SANITARY WARE SPECIFICATION SHEET

/2024 T/J(173/2024)

**Approval of “AMERICAN STANDARD” Bath/Shower Mixer
(General Acceptance No. C20240196)**

Model: WF-6511.611.50

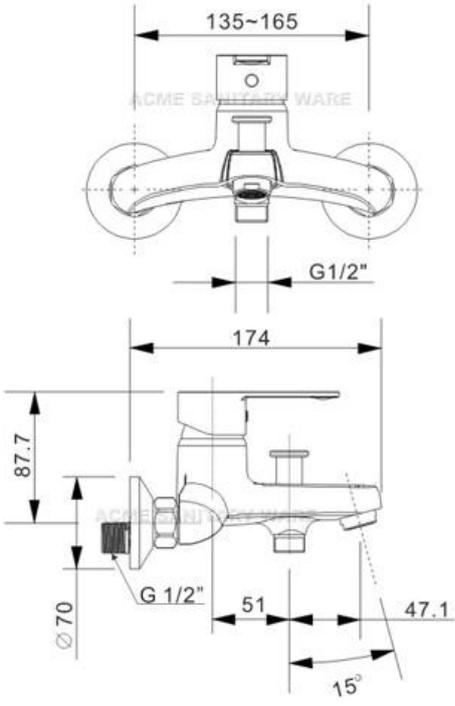
This Authority hereby permits the use of the above fitting in fresh water plumbing systems subject to full adherence to Waterworks installation requirements. In particular, you are required to draw your customers' attention to the following requirement-

"The cold water supply to the fitting shall be drawn from the same source that supplies the hot water apparatus so as to provide a balanced pressure and to obviate the risk of scalding in the event of a restriction or failure in the water supply." AND

"The shower head or handspray should not be placed in submerged conditions and should be securely fixed to the original position after use."

A condition of this acceptance is that the fitting to be installed shall be replicas of the sample as certified by the testing agent mentioned above and without modifications. This acceptance may be withdrawn at any time if the standard of the fitting installed fails to meet that of the approved sample or if the fitting is found to be unsuitable for use in fresh water plumbing systems.

This acceptance is only applicable to the main body of the fitting, unless otherwise specified.
